Tech Tips

TT 60-16-02

2015-2017 Golf, GTI – Sunroof Frame/Water Channel/Drain Pan Replacement

Patch locations (both front corners of water channel)

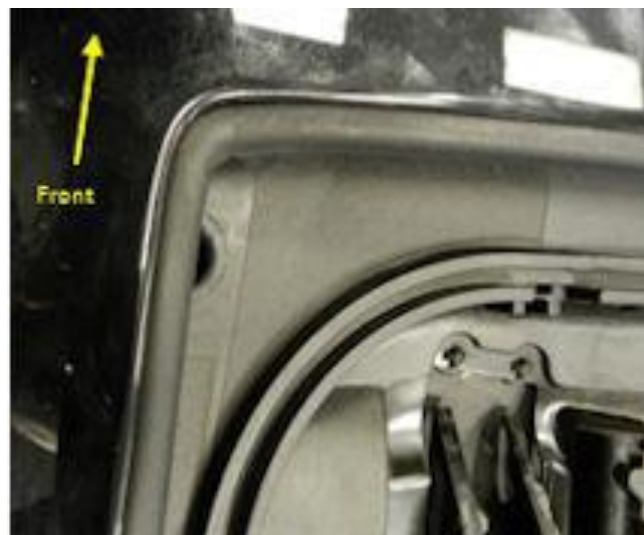
If replacing the sunroof frame/water channel/drain pan (part number 5GM.877.045*), the 8 foil patches from the sunroof water channel repair kit (part number 5GM.898.041) must be installed on the water channel. If the foil patches are not installed, please refer to Technical Bulletin 2045403 for the installation instructions. Failure to install the repair kit can result in repeat customer concerns.

Positions 1 and 2 installed

Positions 3 and 4 installed
